**AGENDA
TECHNICAL REVIEW COMMITTEE
REGULAR MEETING
JUNE 10, 2021
9:00 AM
CITY HALL COMMISSION CHAMBERS
204 ASH STREET
FERNANDINA BEACH, FL 32034**

SETTLERS COVE

Technical Review Committee: Application - Submission #6424

SETTLER'S COVE
SINGLE BUILDING DESIGN

INFILTRATION : 14TH STREET - SOUTHERN POND

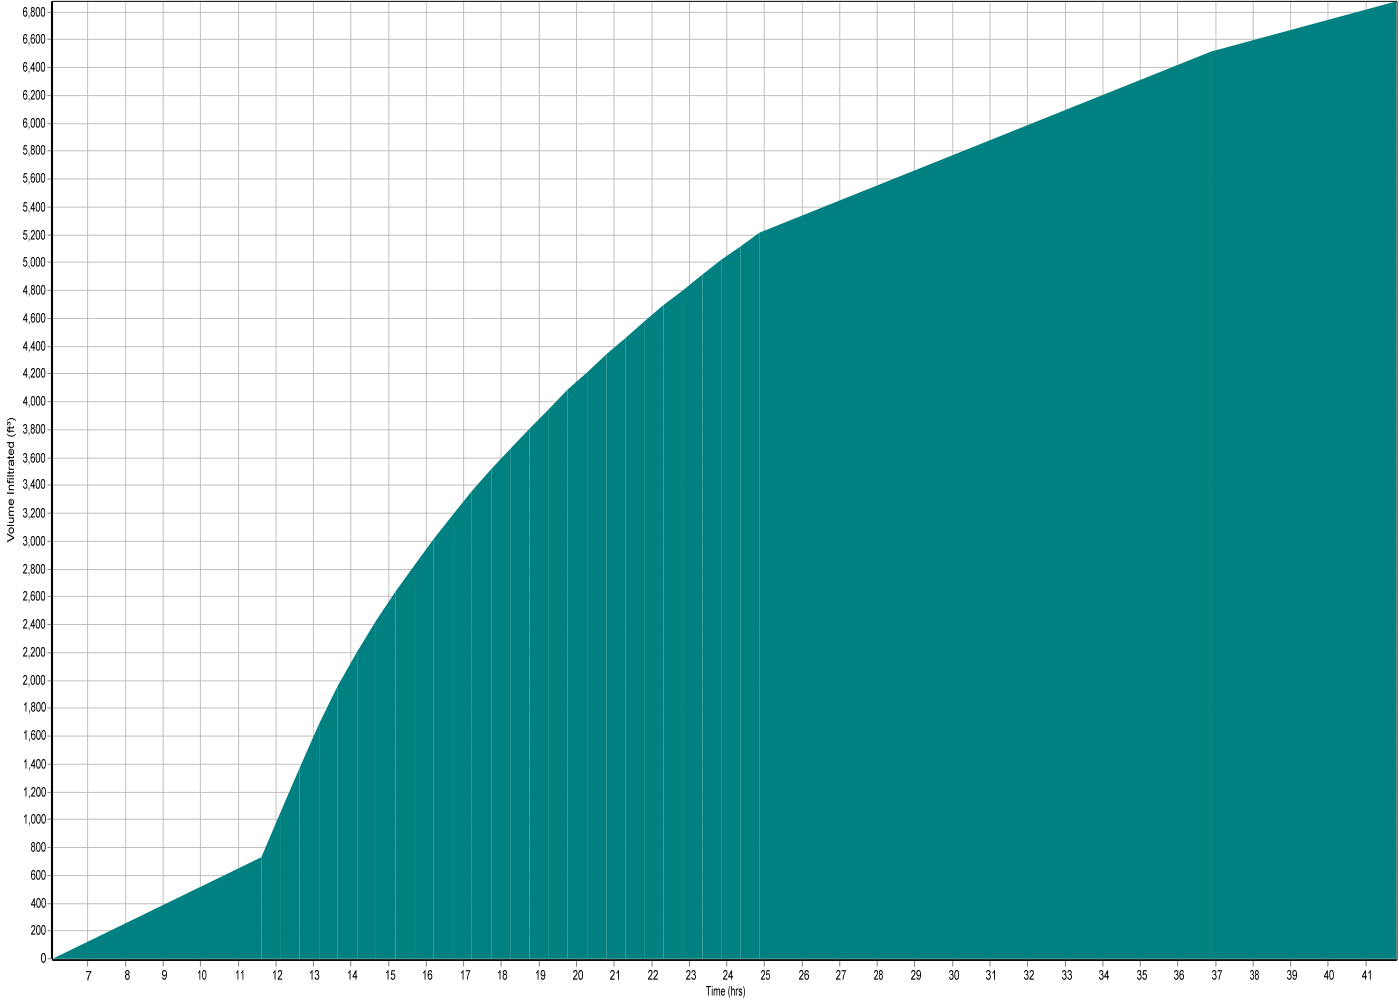
• Please provide drainage analysis for the 10 yr-24 hr storm event (LDC 7.03.03 F (1)a)

A revised drainage report is attached showing this 10-year storm event. A revised description of the changes are reflected in the project summary within this report.

The 10- year storm was analyzed per a request by the City of Fernandina Beach. As a result, a 6-inch pipe was added to outfall the primary system to an outfall swale on the southern portion of the site. A second 12-inch pipe is also proposed as an emergency outfall from this centralized retention facility. A final 3rd outfall will be through an inlet near South 14th Street.
